2911 RC STUNT ROADWAY FCC SCHEMATIC

Title
RC STUNT ROADWAY (TRANSMITTER) - FINAL RELEASE

Size	Document Number	Rev
A	2911txB.SCH	B

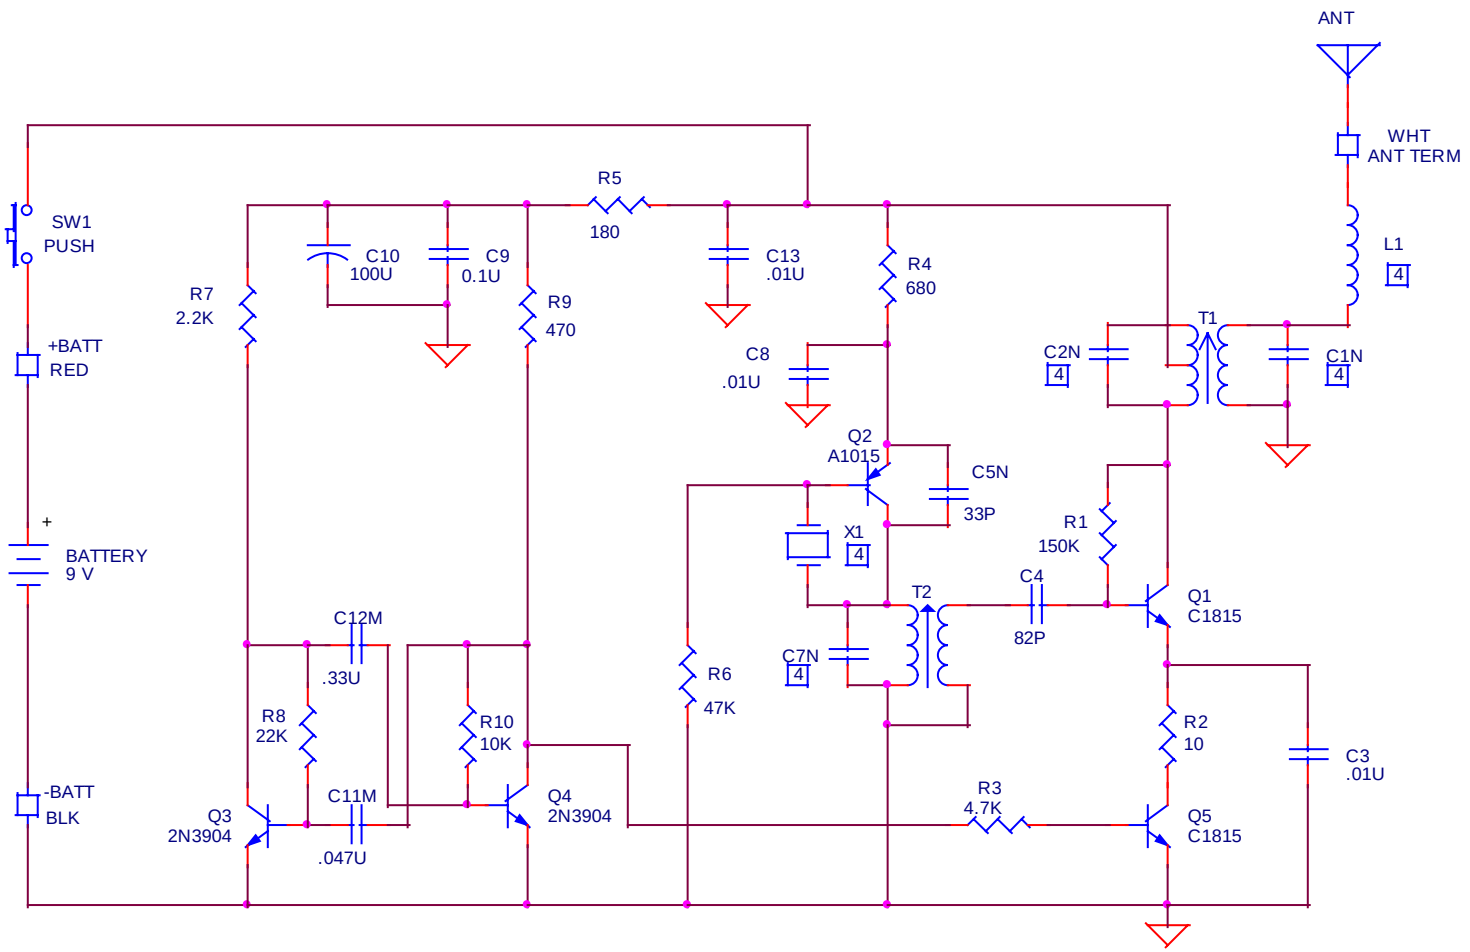
R4 CHANGED FROM 180 TO 680 FOR FCC COMPLIANCE

CHANGES:
R4 180 to 680
